ENGINE

CATEGORY 2.

ENGINE REAR MOUNTING AND REAR EXTENSION BRACKET.

Engine Rear Mounting.

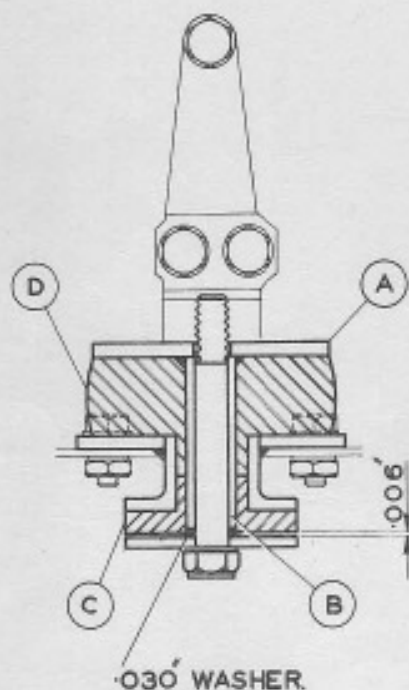
On certain vehicles it has been found that when the engine rear mounting bolt is fully tightened, the upper washer of the rear mounting distorts slightly to conical form, so that it seats only over an area close around the bolt hole in the undersurface of the bracket. This permits relative movement between the upper washer and the bracket, which may eventually cause fatigue failure of the engine mounting bolt at that point.

The rear engine mounting is also to be checked to ensure that the lower rebound rubber is not held tight but has .006" vertical clearance, when the assembly is tightened in position with the engine load on. If there is insufficient clearance a .030" thick steel washer is to be placed between the lower steel washer of the assembly, and the distance tube, taking care to ensure that the washer seats directly on the base of the distance tube, and does not foul the inside of the hole in the rebound rubber. Alternatively the distance tube can be lengthened .030" by welding and machining to a length of 2.045".

This is overcome by machining a counterbore in the undersurface of the rear extension bracket .750" in diameter and .005" - .010" deep, so that should the upper washer distort, the effective seating will not be confined close to the bolt hole, but to the diameter of the counterbore.

When the engine mounting bolt has been finally tightened, the rebound rubber should have a .006" minimum vertical clearance.
